**Re: Stormwater Sampling and Analysis Plan – Revision 1
Akron Airdock, Akron, Ohio
Voluntary Action Program (VAP)**

**STORMWATER SAMPLING
AND ANALYSIS PLAN – REVISION 1**

AKRON AIRDOCK, AKRON, OHIO

FIGURE 2
STORM SEWER SYSTEM WITH
FACILITY SAMPLING LOCATIONS

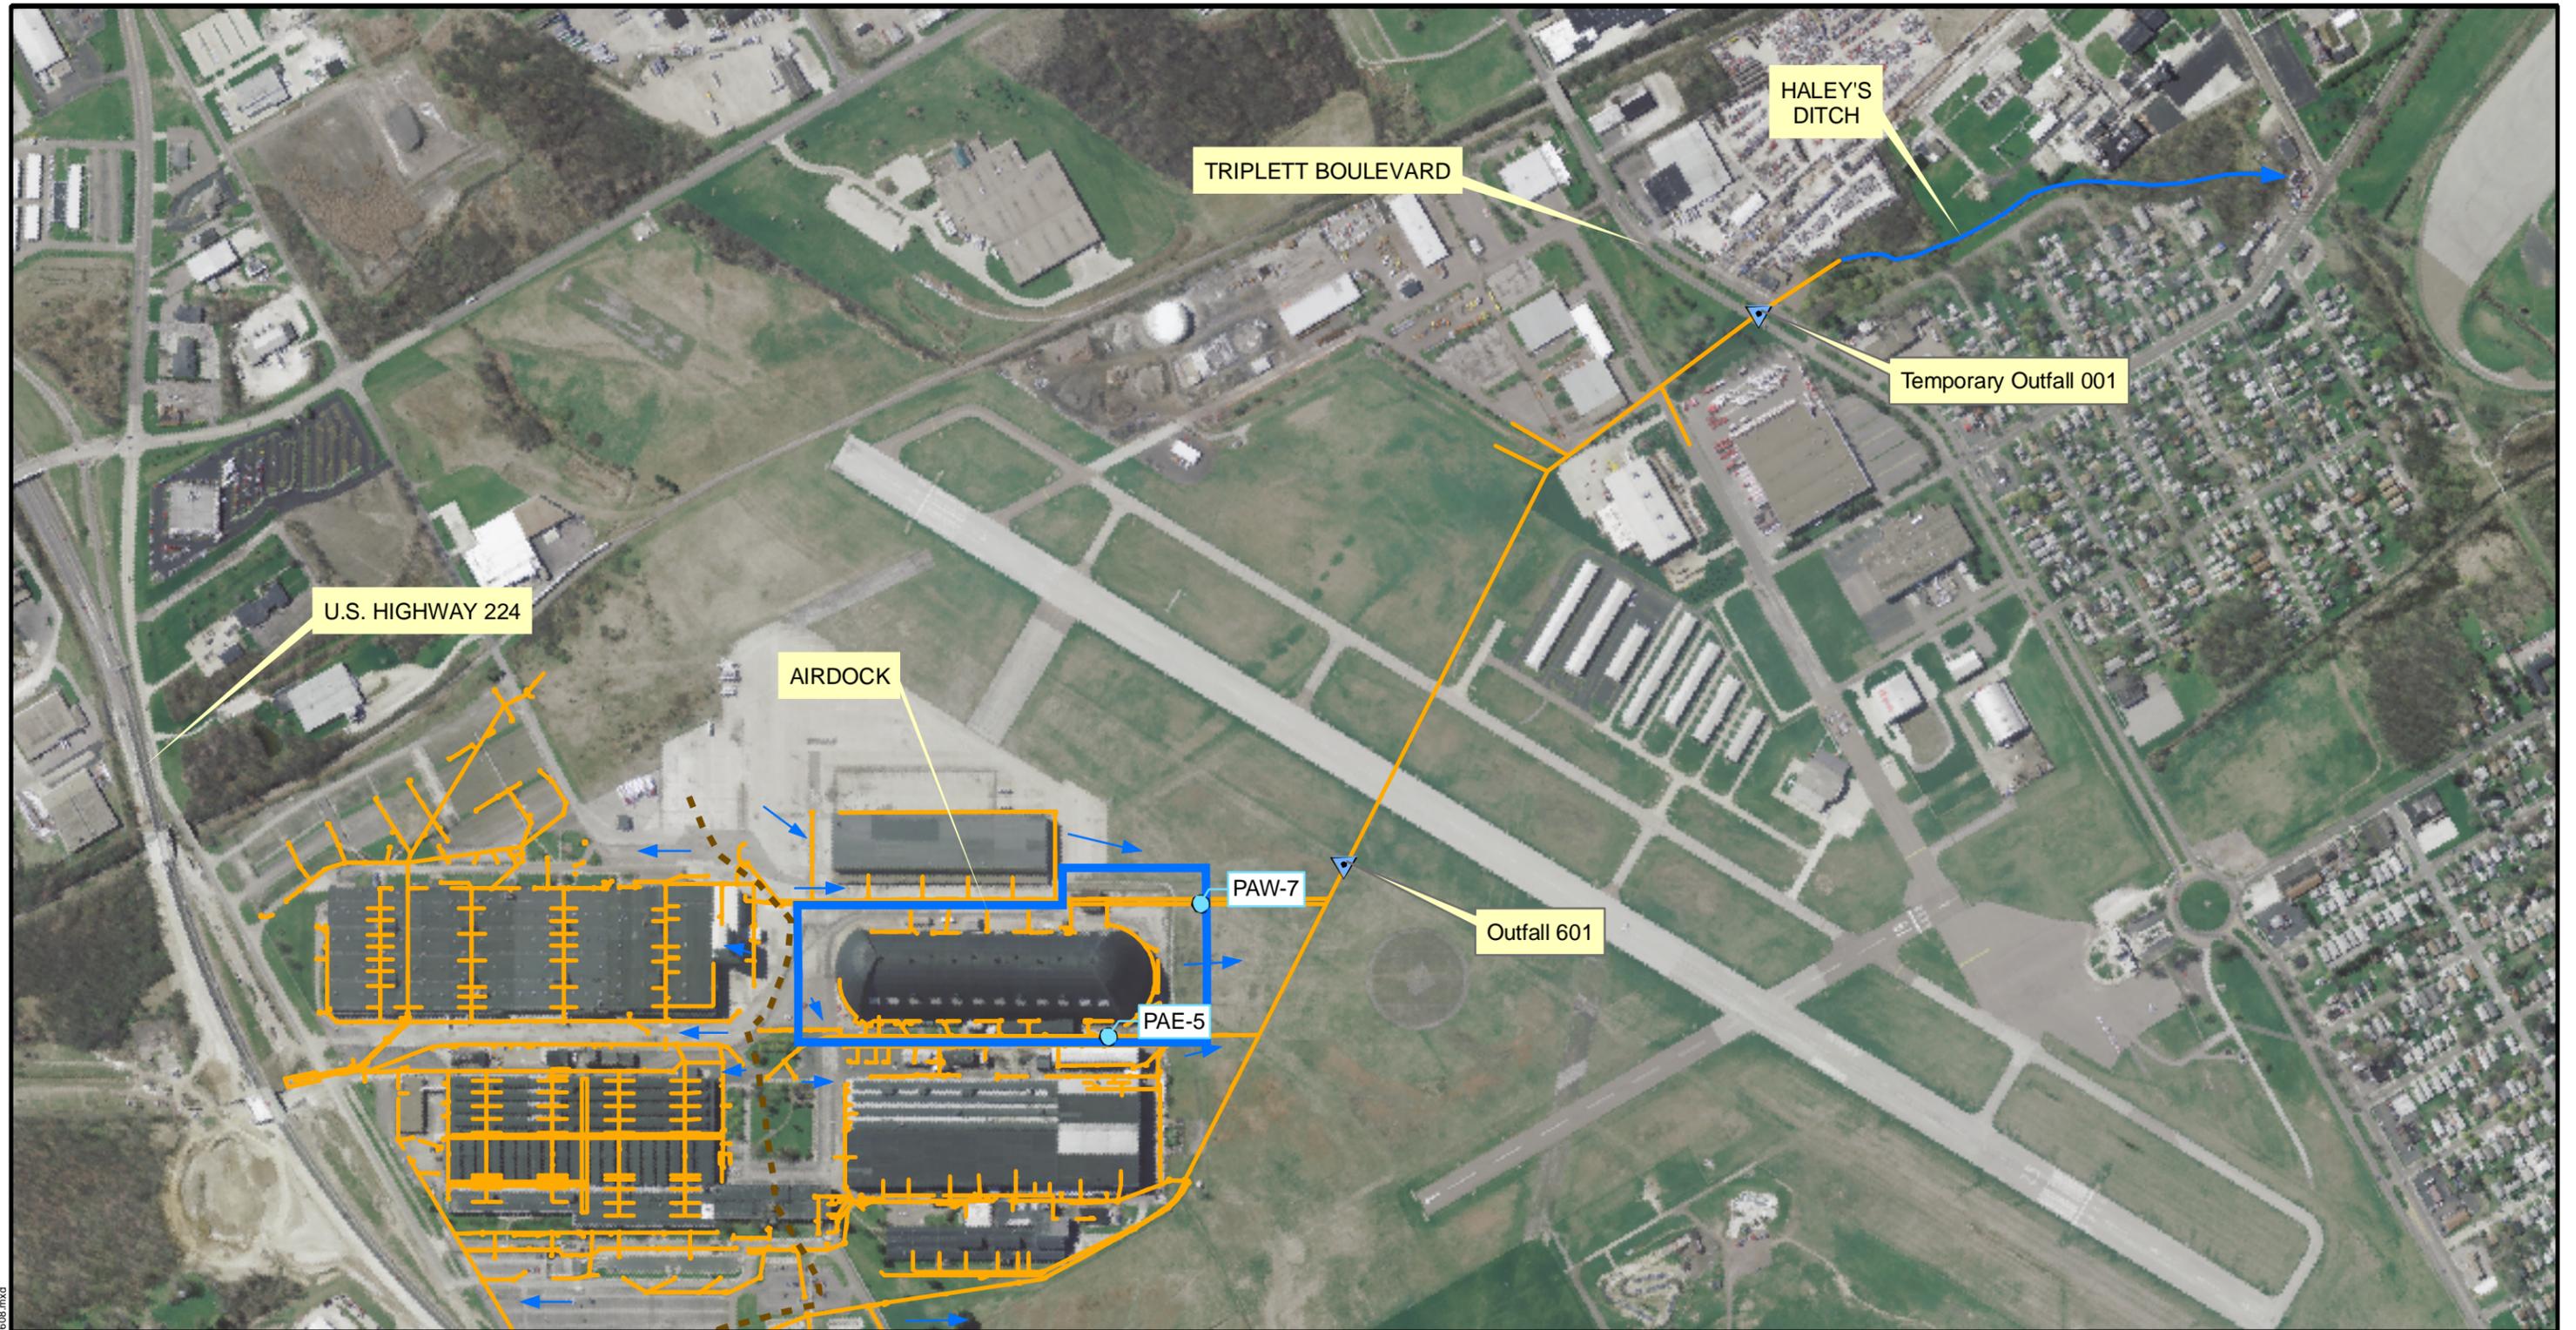
2) Section 4.2.2, Typo: *The last sentence of this section refers to sampling point CBI462 as one of the sampling points. However, Figure 2 shows sampling point CBI492. Please provide the correct numbering for this sampling point.*

Response: CB1462 is the correct sampling point designation. Figure 2 has been corrected.
